PUBLIC HEARING MEMORANDUM

SUBJECT: **Petition #259-19**, for SPECIAL PERMIT/SITE PLAN APPROVAL to allow Single-Family Attached Dwellings with waivers to the dimensional standards at **264 Pearl Street**, Ward 1, Nonantum, on land known as Section 11, Block 14, Lot 10, containing approximately 14,608 sq. ft. of land in a district zoned MULTI RESIDENCE 2. Ref: Sec. §3.2.4, §3.4.1, §5.4.2.B, §6.2.3.B.2, §7.3.3, and §7.4 of the City of Newton Rev Zoning Ord, 2015.

264 Pearl Street

Existing Site Plan

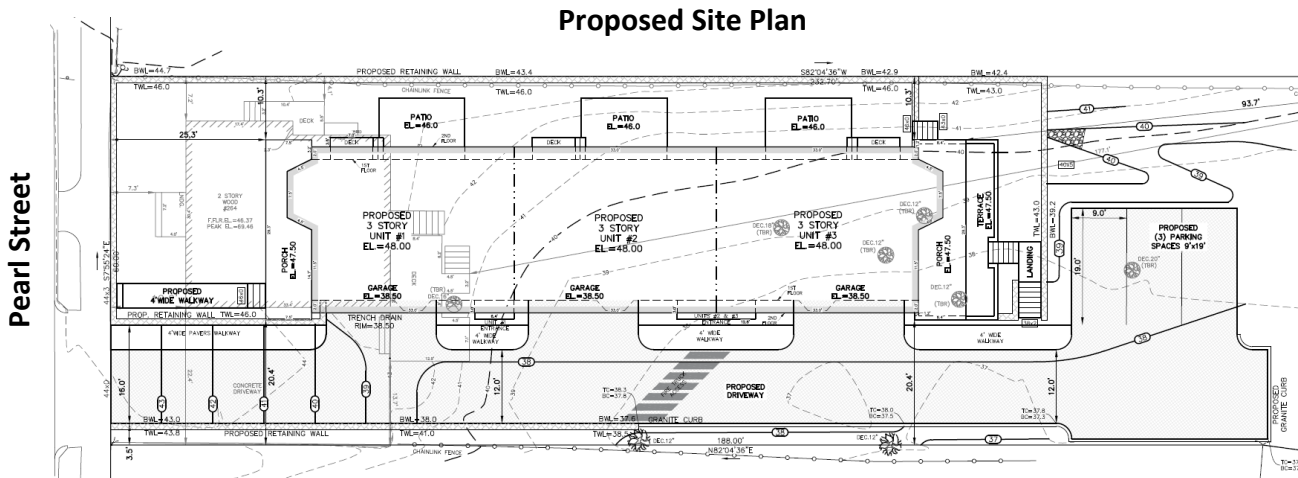
The site consists of 14,608 square feet of land and is improved with a two-story, two-family dwelling constructed circa 1905; the architecture of the dwelling is classified as a Worker Cottage. The structure is 23-feet tall and has a nonconforming front setback of 7.3 feet, where 25 feet is required. The structure also has a nonconforming side (south) setback of 4.1 feet where 7.5 feet is required. The front quarter of the lot has a noticeable change in grade, but towards the middle and rear of the lot the grade flattens; the rear of the lot is five feet lower than the front. There is an approximately 22-foot-wide curb cut at the northern portion of the site providing access to a four-stall surface parking facility. The site is sprinkled with mature landscaping and the northern and southern boundaries are enclosed with fencing.

Proposed Right Elevation

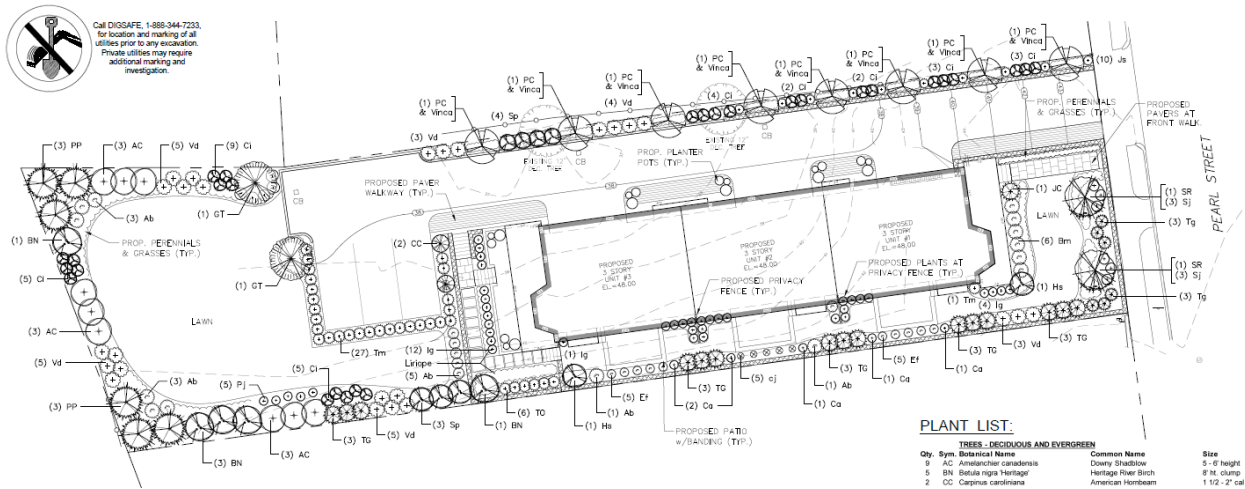
The Planning Department is unconcerned with the increase in dwelling units from two to three, but staff is concerned that the structure will present as out of context to the neighborhood. As such, the Planning Department suggests that the petitioner work to break down the massing of the structure, by providing articulations, diversifying the roof forms, or offering a range of unit sizes.

The Attached Dwellings will be constructed one behind the other from the front of the lot to the rear. The front unit will feature a porch and a prominent front door to Pearl Street, while the middle and the rear unit will be oriented to the driveway and to the side lot line. At the northern and southern facades, the Attached Dwellings will feature three gable peaks demarcating the different units with a continual ridge line. The Attached Dwellings are approximately 30-feet tall, but they present differently to different facades, due to the grading. The Attached Dwellings appear to contain 3.5 stories from the northern boundary, while appearing to contain 2.5 stories from the southern and Pearl Street facades. Similarly, the Attached Dwellings measure 35.5-feet tall at the northern facade, 33-feet tall from Pearl Street, but only 27.5 at the southern façade.

Street. This lack of frontage also requires relief from the side setbacks as a wide lot would be more likely to accommodate the required distance. To minimize the relief for setbacks, the petitioner has constructed the Attached Dwellings in a line which may present as out of context with the neighborhood. As such, the Planning Department suggest that the petitioner work to break down the massing along the northern and southern facades by incorporating articulations, diversifying roof forms, or offering a mix of unit sizes.
